**Subject: C1 Diversion – NWB and DFO Comments
Jericho Diamond Project, NU**

Further to a request by Tahera Diamond Corporation (TDC), EBA Engineering Consultants Ltd. (EBA) was retained to address comments by the Nunavut Water Board (NWB) and Department of Fisheries and Oceans (DFO), regarding the proposed C1 Diversion development at the Jericho Diamond Mine in Nunavut.

**Subject: Jericho Diamond Mine
C1 Diversion
Response to DFO**

**Channel Parameters in Reach A
Figure 1**

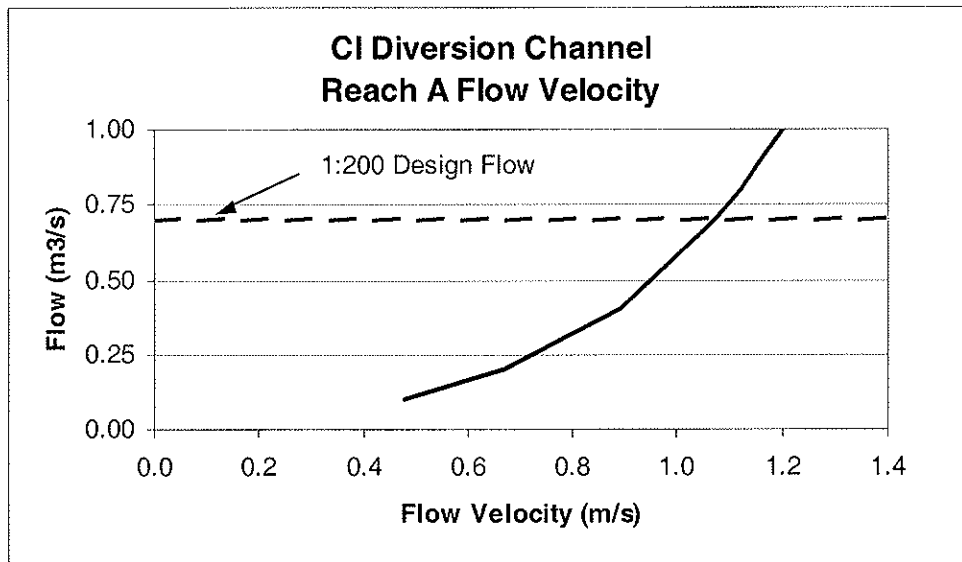
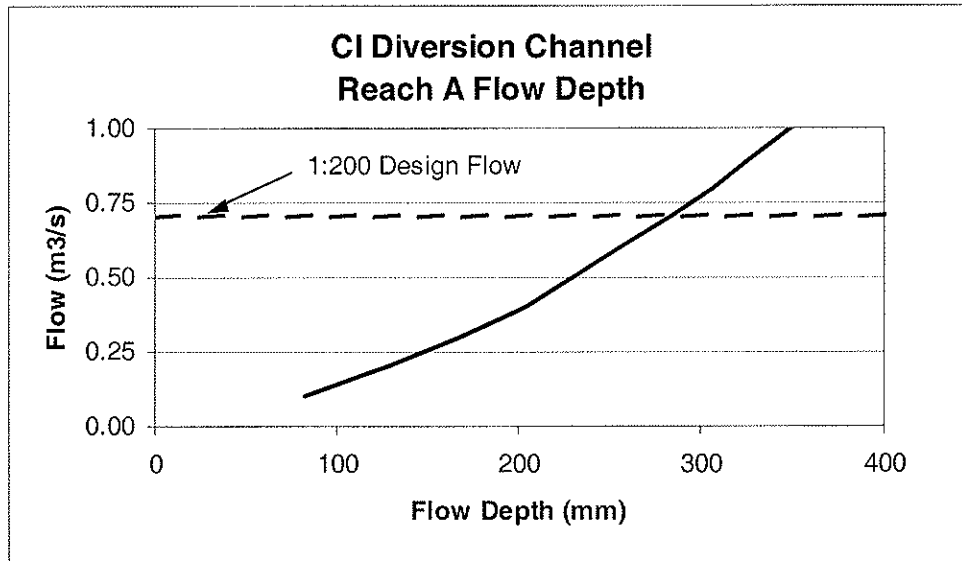
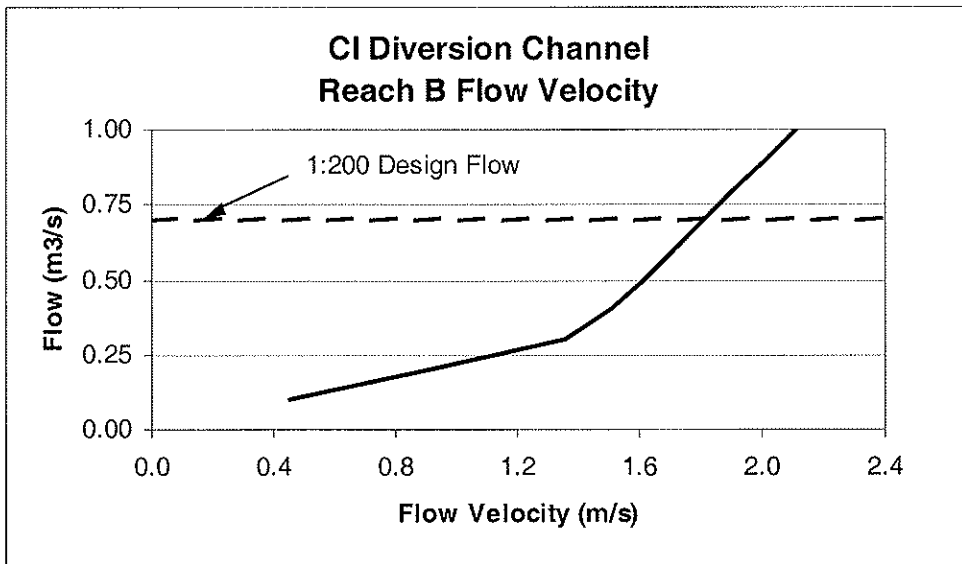
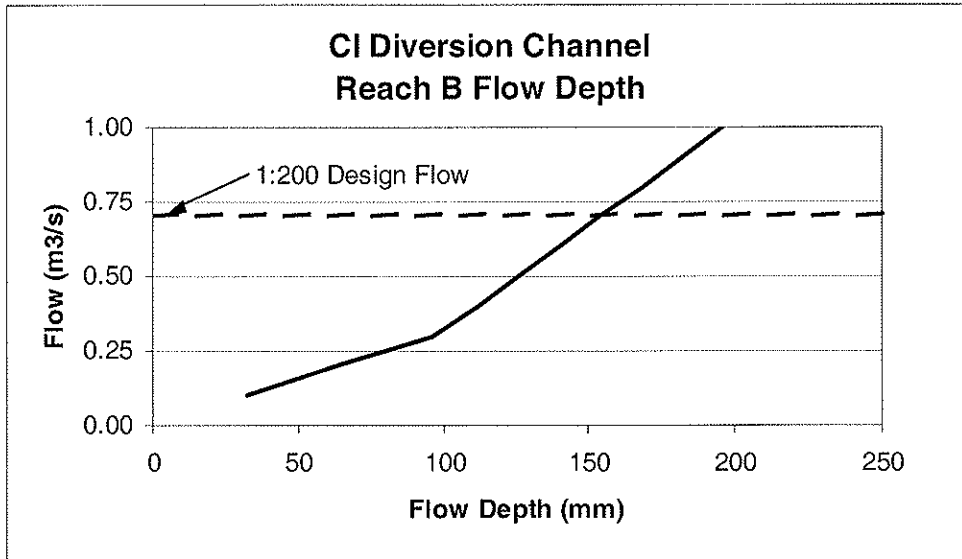
- “2. The construction of berms on either side of the diversion channel will further reduce the size of the C1 drainage area and consequently the amount of runoff available for the diversion. The additional reduction in water supply in the C1 drainage area needs to be determined and detailed flow information provided such as water depths, flow rates and duration. Furthermore, information on the duration and frequency when fish will be unable to use Stream C1 due to the lack of water needs to be provided along with the overall ability of Stream C1 to support various fish life history stages.”**

Attached Figure C18 (from SRK's 2004 Supplemental Climate and Hydrology, Technical Memorandum C) provides flow measurements collected by SRK at the discharge from C1 Lake. This information illustrates pattern of discharge measured to 2001. Figures 1 to 3 attached show maximum theoretical flow depths and velocities as a function of discharge for Reaches A, B and C.

Figure C.18: Comparison of Estimated and Observed Flows for Stream C1 below Lake C1

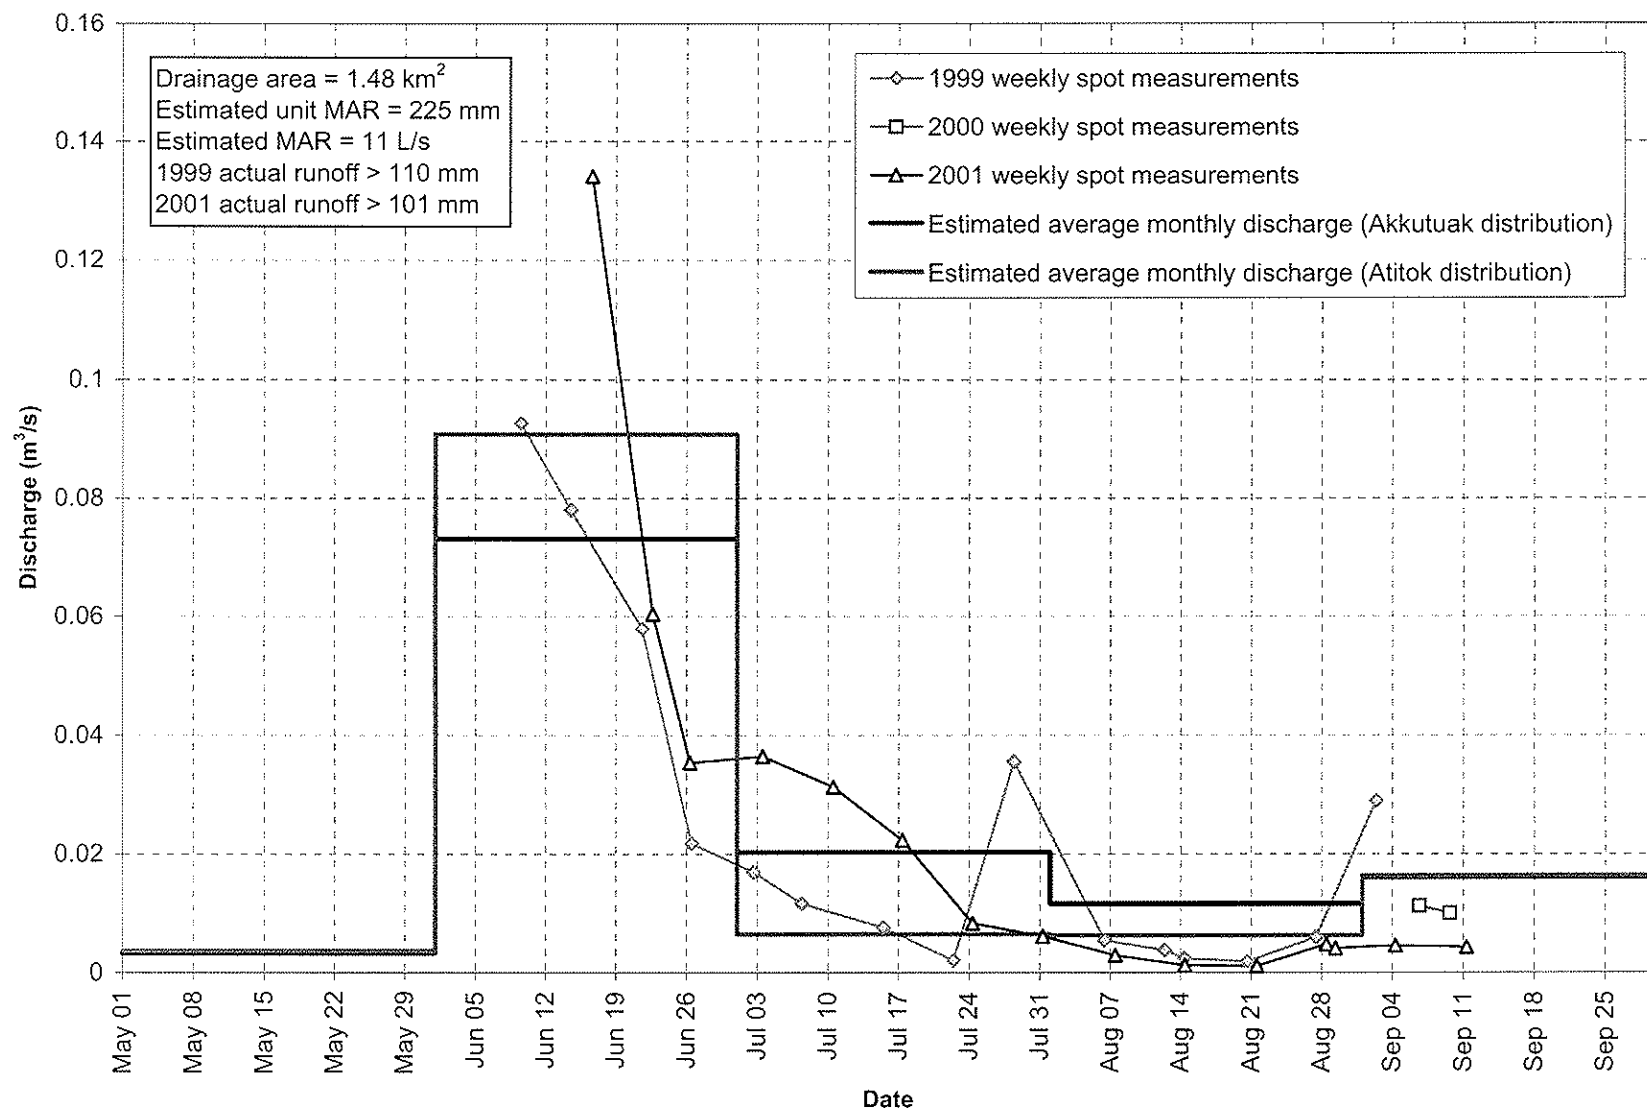
- “3. The diversion channel has been designed for a 1:200 year precipitation event to ensure protection of the pit from overtopping and failure of the channel banks. It is recognized that this channel width would not be conducive to enhancing fisheries values and as such a smaller low flow channel has been designed into the larger channel. However, it is not clear what precipitation event the low flow channel has been designed for. Typically, 1:2 year precipitation events define and maintain the channel characteristics, which create stable conditions for biological activity. Therefore, the smaller low flow channel should be designed with this in mind. “**

Figure C18 presents one of the source documents showing C1 observed flows patterns and discharges that were referred to for SRK's and our design. In 3 years of data collection, the patterns of flow were compatible with regional patterns and were used as the baseline information for all approvals to date. Much of the measured flow at the C1 Lake outlet is in rock and constitutes the primary source of water to C1 diversion. This diagram shows that flows are highest at the time of snowmelt and that within a short time the flow volumes decline by an order of magnitude. High intensity rainfall events result in surges of flow, however, these rainfall events contributions are still small.

TYPICAL FIELDSTONE RIFFLE

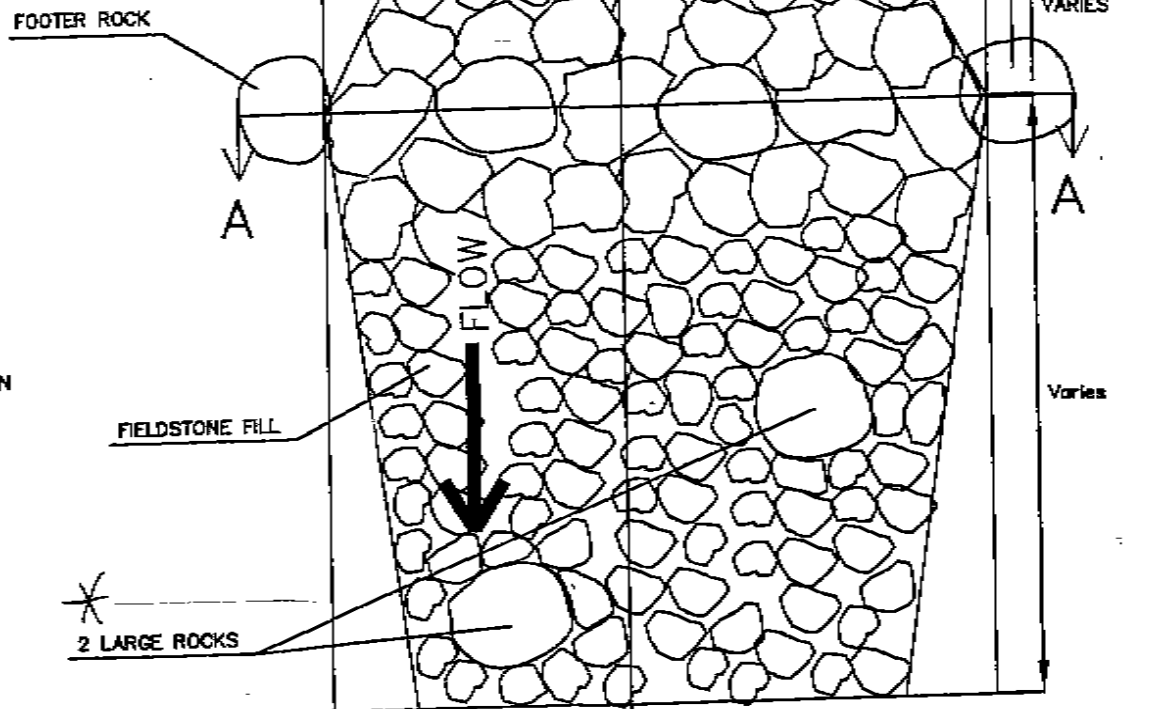
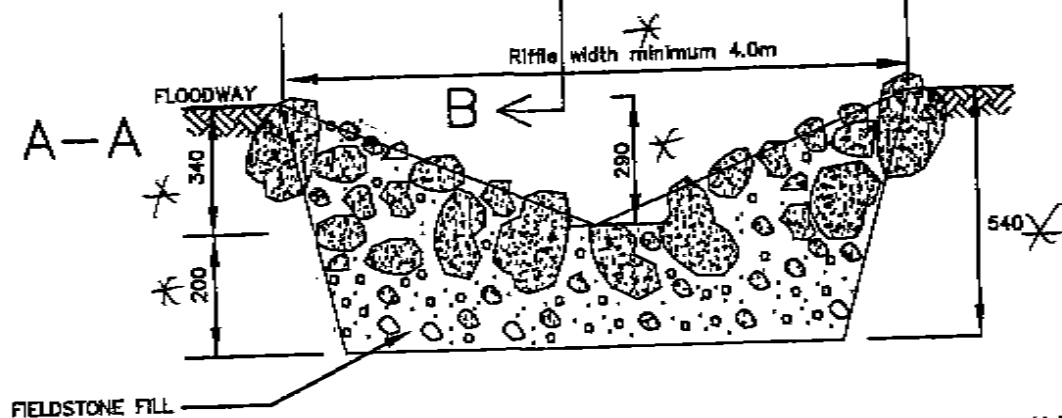
DFO Comment 4- Riffle Design:

Details of the plans for the riffle design and locations were not originally provided by EBA. - -

TDC will construct riffles in detail as appropriate later in the year after the channel is at low flow/no flow conditions. The exact location and design may require some field fitting, however, TDC agree to use the Newbury design (a copy of which was faxed to EBA on December 12, 2005, see Appendix C). This design will be considered by EBA as a preliminary design and will be adjusted accordingly and will make use of appropriately sized rounded stone. The locations will be initially identified as the straight areas between the meander bends, subject to further adjustment based on observations of the early performance of channel.
